**PROPOSED RESIDENTIAL DEVELOPMENT,
FORMER LILLEY AND STONE HIGH SCHOOL LONDON ROAD NEWARK, (3876)
APPLICATION REFERENCE PREAPM 00260 23
RESPONSE TO NOTTINGHAMSHIRE COUNTY COUNCIL COMMENTS - DECEMBER
2023**

This note has been prepared in response to comments received from Nottinghamshire County Council (NCC) dated 24th November 2023.

The comments concern the Transport Assessment (TA) submitted in October 2023 in support of PREAPM 00260 23 for Full Planning permission for Demolition of existing buildings, conversion of 3 no. retained heritage buildings to provide 32 apartments and erection of 43 new dwellings including access, parking and landscaping; and Outline planning permission for the erection of up to 64 new dwellings (all matters reserved except access) at the former Lilley and Stone High School, London Road, Newark.

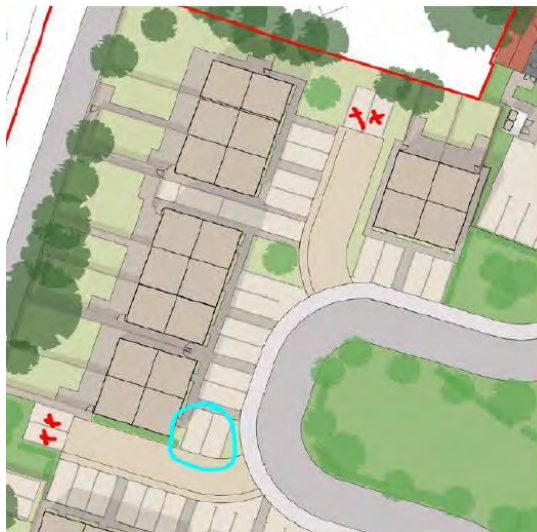
- **There is no widening on the bends. This should be determined by tracking a large car and a delivery vehicle, with suitable offsets.**
- **Pedestrian and vehicular visibility splays are required to be shown from all private drives serving 2 or more dwellings.**
- **Bin collection points are required close to the rear of highway and must not conflict with pedestrian visibility splays.**
- **Please note that the parking for the flats would need to be served by a dropped vehicular access as opposed to the bellmouths shown, to give pedestrian priority.**
- **Is the footway running north south across the Public Open Space to be offered for adoption? If not, the layout does not provide adequate footways.**
- **A service strip is required adjacent to carriageway but is not shown. A hard surfaced one would need to be 750mm, but grass ones are required to be 2 metres.**

- Swept-path tracking for a delivery vehicle and a large car has been undertaken as shown in **Drawing No. 3876-SP03**, there is sufficient road width (albeit using both sides), for a delivery vehicle and large car to pass one another with substantial forward visibility as shown in **Drawing No. 3876-01**. Furthermore, it is considered unlikely that large delivery vehicles will be travelling through the site at peak times or in significant numbers to raise a safety issue. Therefore, a condition requiring the height of landscaping to be kept to a maximum of 0.6-metres would be acceptable.
- Visibility splays are shown for all private driveways serving two or more dwellings, throughout the site, as shown in **Drawing No. 3876-01**.
- The provision of bin collection points will be addressed at the detailed design stage.

- A condition requiring the provision of dropped kerbs to access the flats parking areas will be acceptable.
- The footway running north-south across the Public Open Space will be offered for adoption.
- A 2-metre-wide footway will be provided along the grassed areas adjacent to the carriageway, as shown in **Drawing No. 1200 P15**.

DRAWING NUMBER: 3876-F01	REVISION: B
------------------------------------	-----------------------

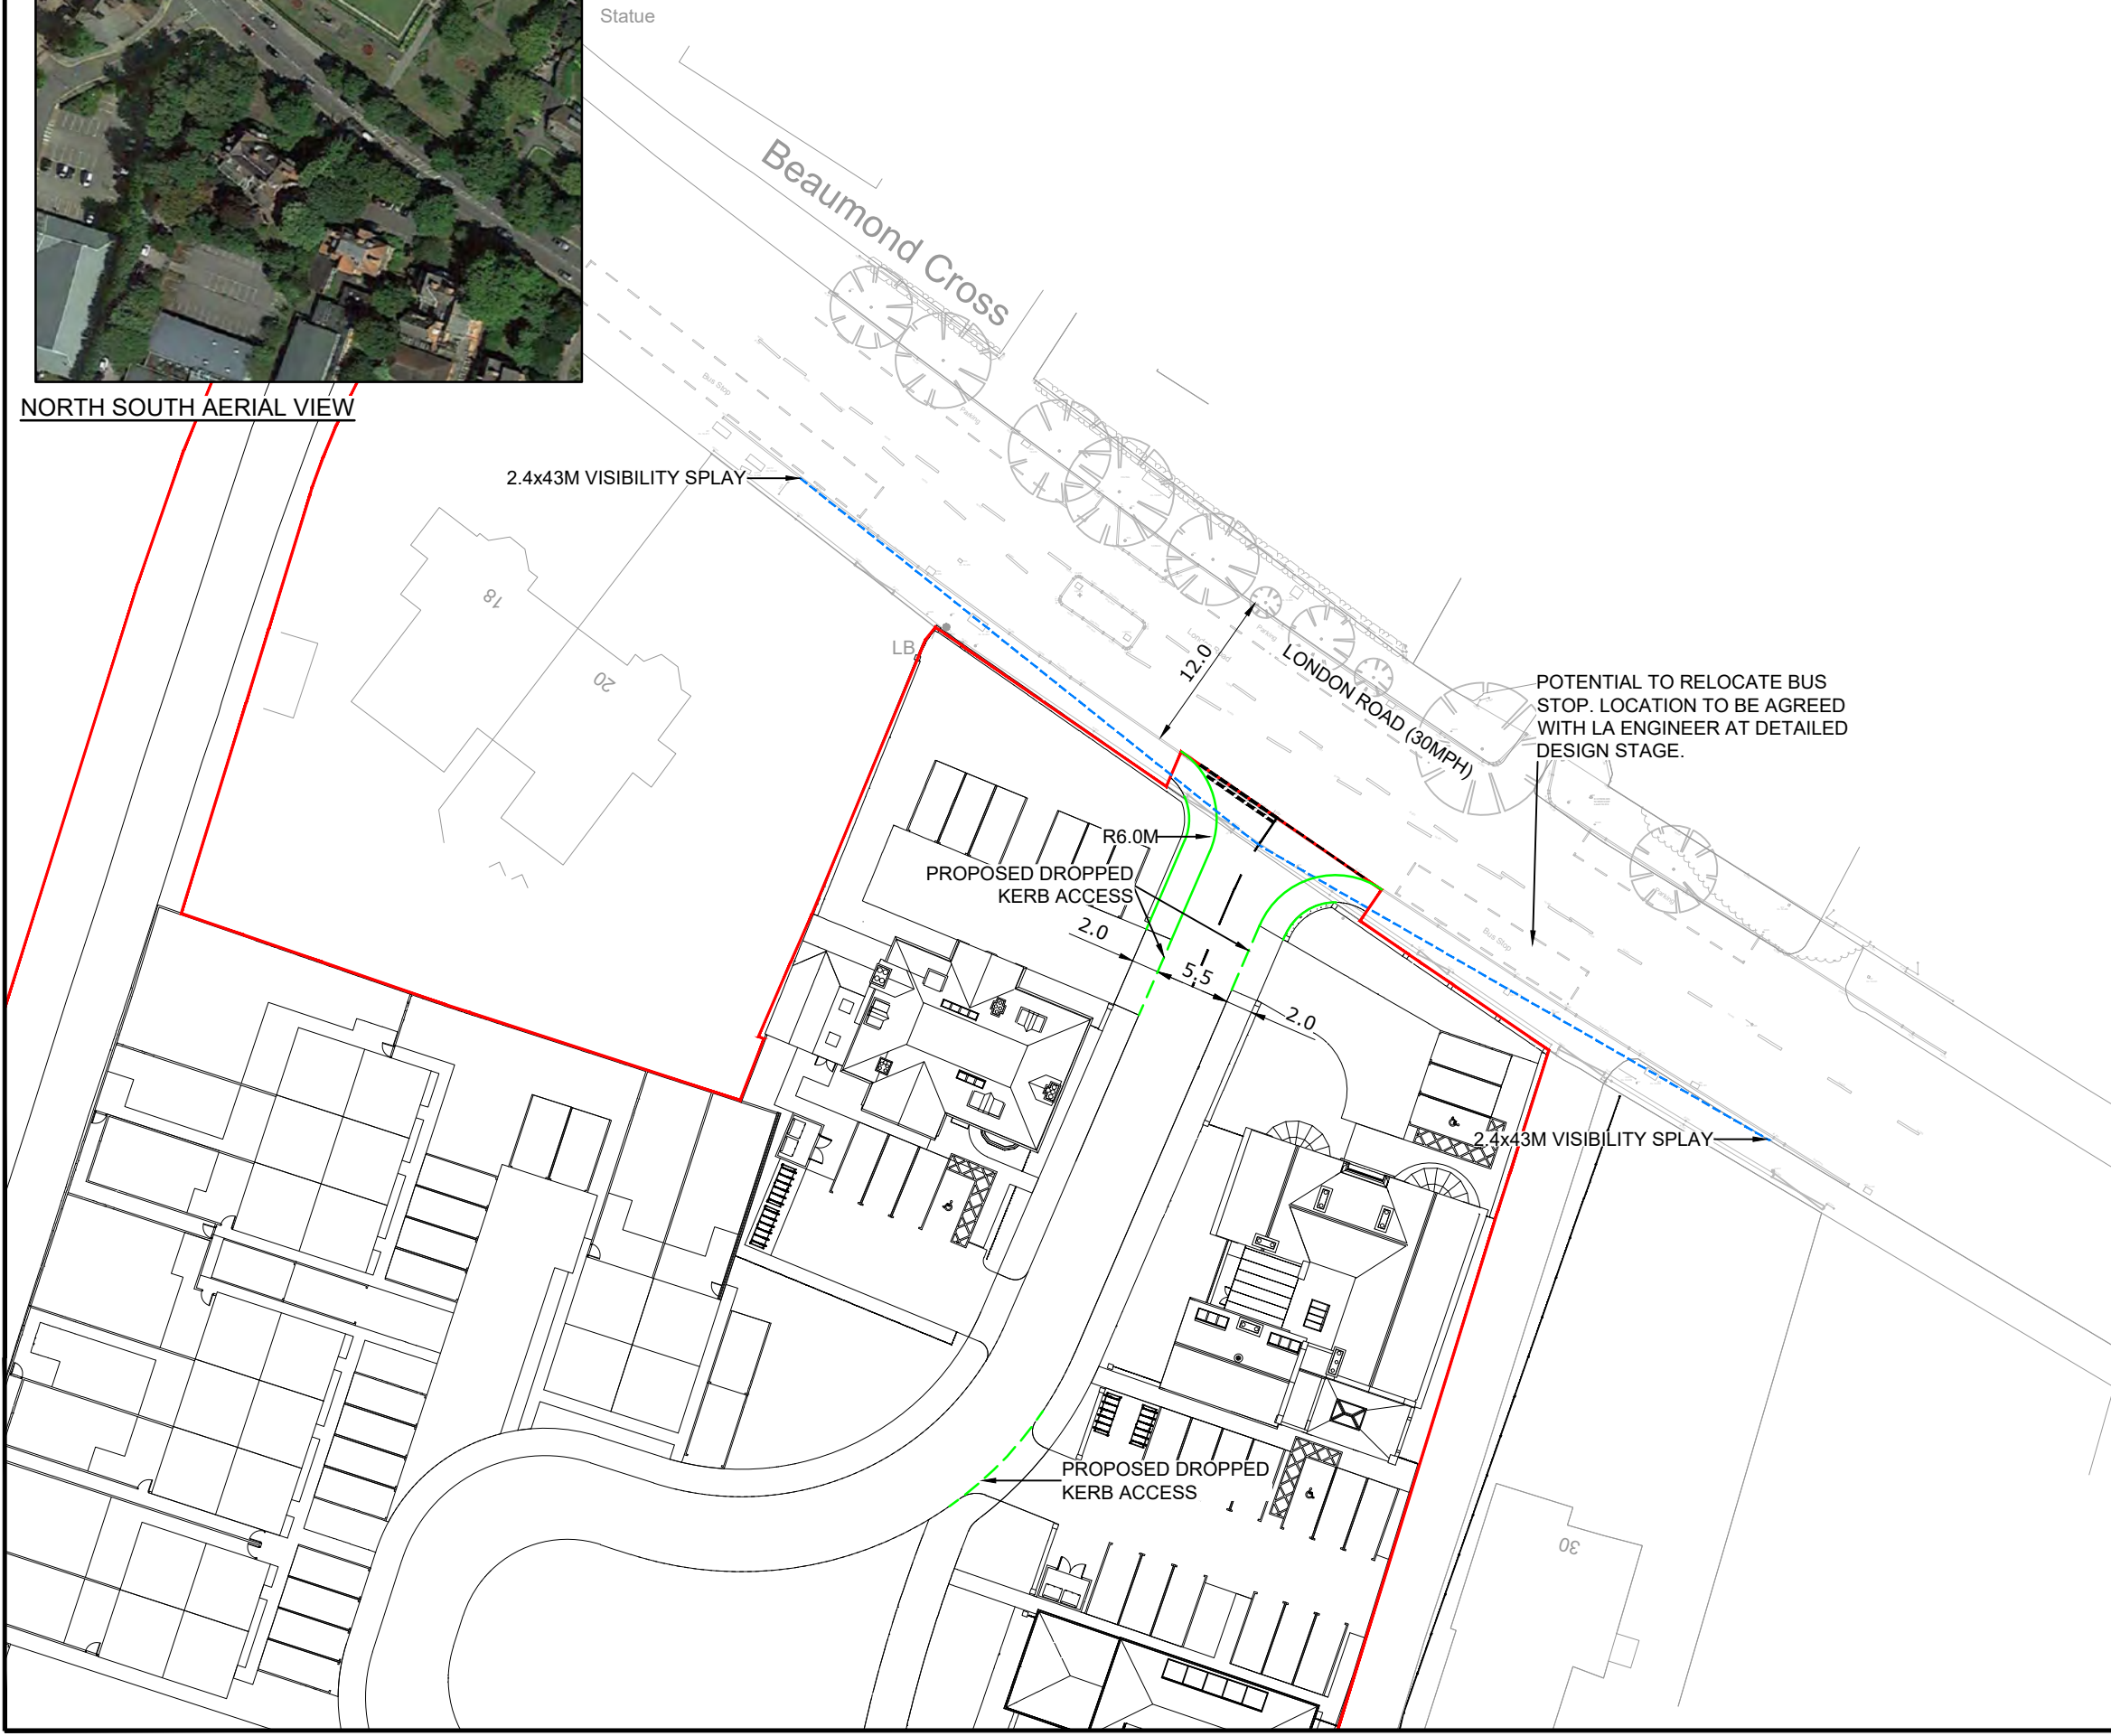
The 'existing' plan shows the distance between the listed dwellings to be just over 8 metres which would not allow the access. It would appear that demolition of a section of Listed Building number 2 is required to enable this.

Similar to the Harewood Avenue proposed access, a drawing indicating the required geometry based on existing speeds has not been submitted. It is also required that a swept path analysis is undertaken to ensure that the existing refuge does not obstruct access for left turning vehicles.

As shown in Drawing ref: 3876-F01 Rev B the distance across the carriageway is 5.5-metres with footways of 2-metres width along both sides of the carriageway.

As previously discussed, the northern site access will have a 5.5-metre-wide carriageway with 2-metre-wide footways along both sides and 6-metre entry radii, as shown in **Drawing ref: 3876-F01 Rev B**.

DRAWING NUMBER:	3876-SP02	REVISION:	C
-----------------	-----------	-----------	---

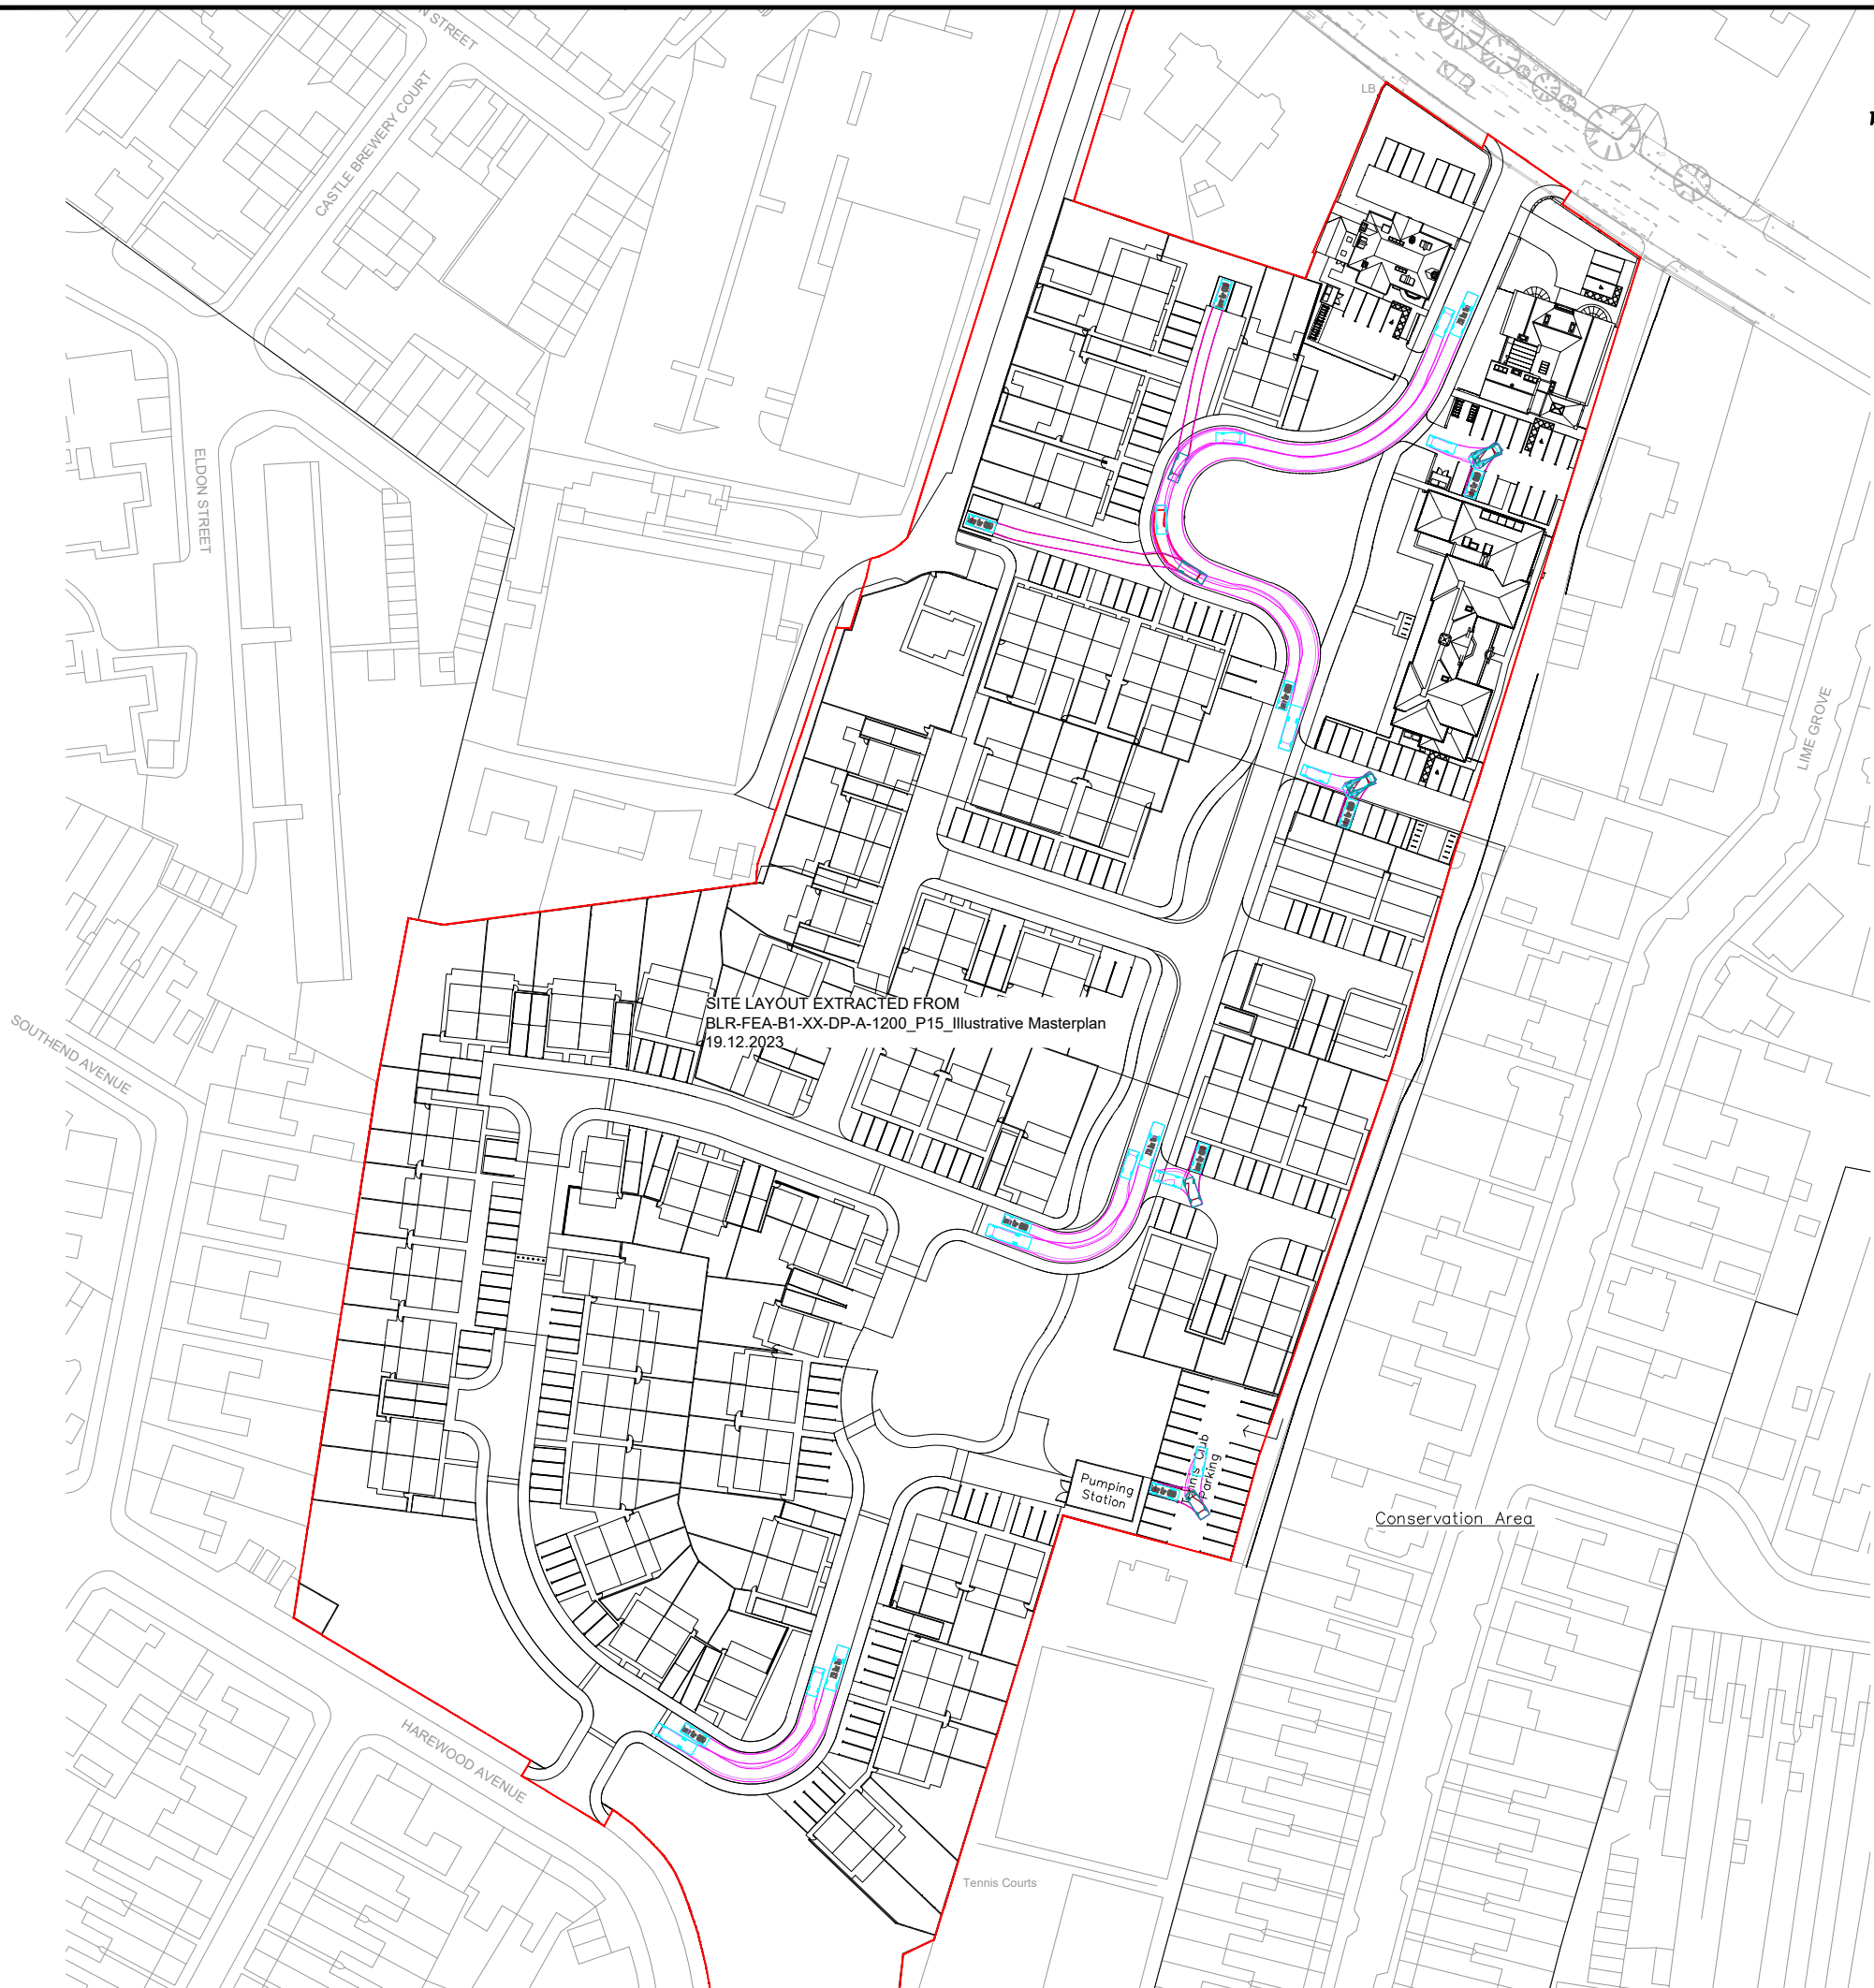
The swept path of the refuse vehicle appears to show it stationary on London Road and dry steering to be able to access the development, subsequently overhanging the footway on the opposite side of the road. The geometry of the access should be amended to allow a vehicle to enter without stopping, particularly on this busy, classified road.

The swept path of an 11.5-metre refuse vehicle has been undertaken, as shown in **Drawing No. 3876-SPo2 Rev D**, demonstrating an 11.5-metre refuse vehicle can enter, access all parts of and exit the site.
